**MODIFICATION REQUEST:  
USYD Central Building, Darlington  
Campus, The University of Sydney  
(MP05\_0164 MOD 3)**

- Removal of stairwell between levels 3 and 4 and infill level 4 void.

Secretary's Environmental Assessment Report  
Section 75W of the *Environmental Planning and  
Assessment Act 1979*

Figure 3: Proposed Level 3

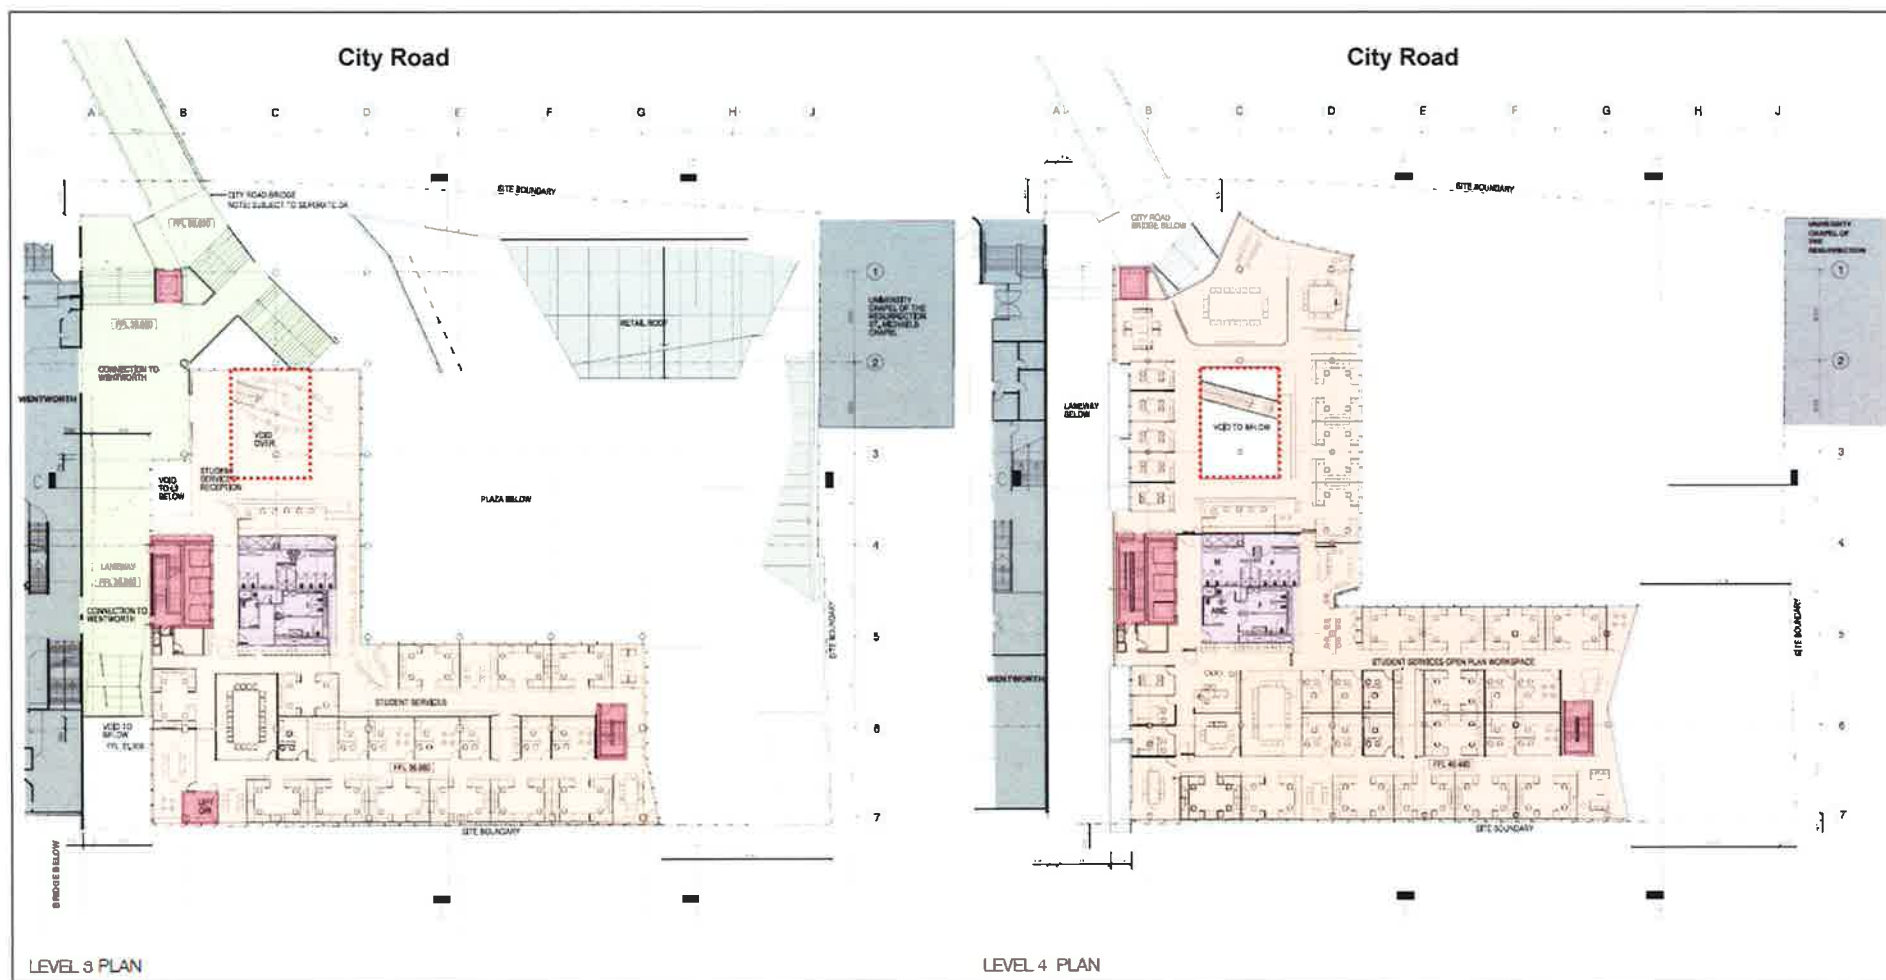
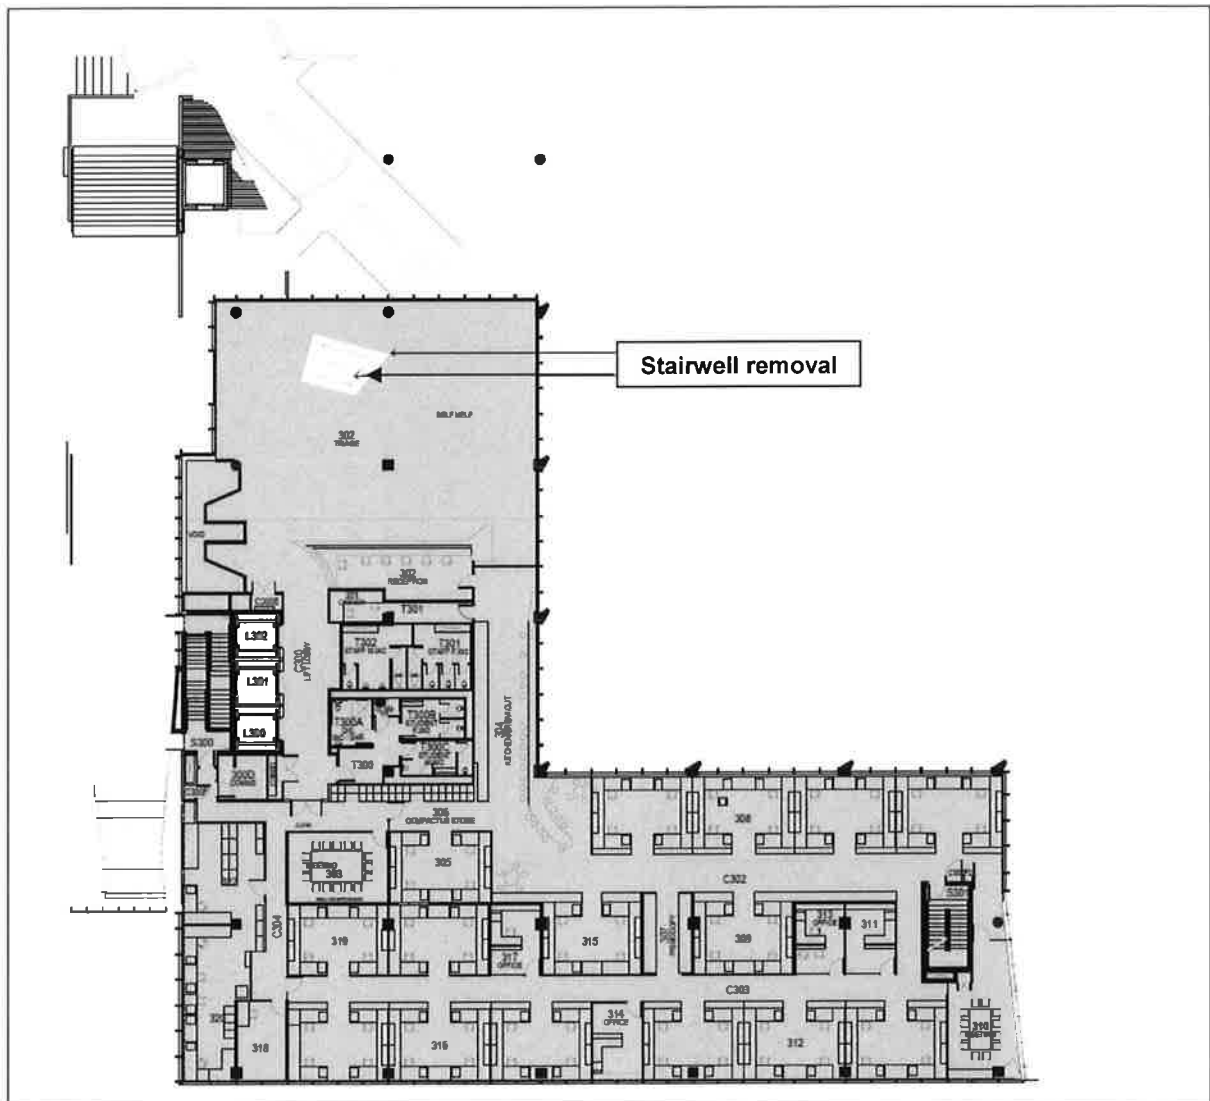
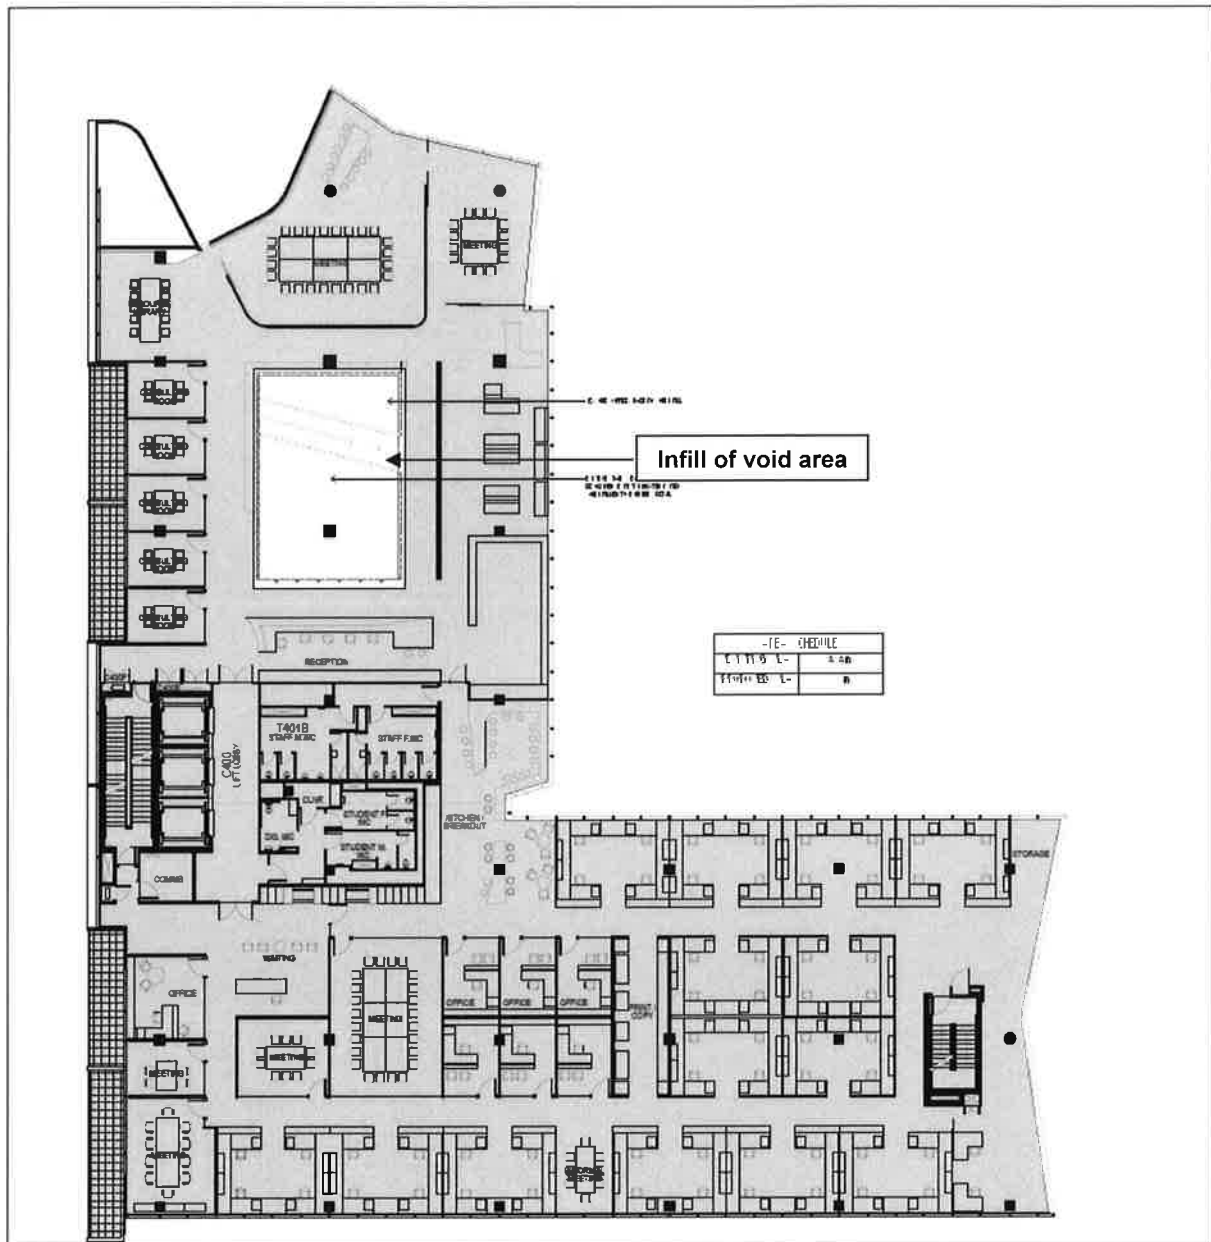
- remove the connecting stairwell between levels 3 and 4; and
- infill the level 4 void area providing an additional 85.88 sqm of floorspace for student administrative purposes (see **Figures 3 and 4**).

The proposed removal of the stairwell between levels 3 and 4 and infill of the level 4 void space is sought by the proponent to provide an additional 85.88 sqm of floorspace for student administration purposes. The proposed additional floorspace is minor in the context of the overall development and being internal and would not contribute to the bulk and mass of the existing building and would not change the external appearance of the building.

The submitted Fire Engineering advice details that while the stairwell is proposed to be removed, sufficient exits will be available to allow building occupants to safely exit the building. It was further noted that the existing building contains additional fire safety systems above that required by the Building Code of Australia (BCA). It was concluded, that the building's internal circulation, as proposed to be amended, would meet the requirements of the BCA via a Fire Engineering Alternative Solution.

The Department has considered the proposed internal amendments to the existing building and raises no objections, noting that sufficient exits and fire safety measures exist within the building to ensure that compliance with BCA requirements is maintained.
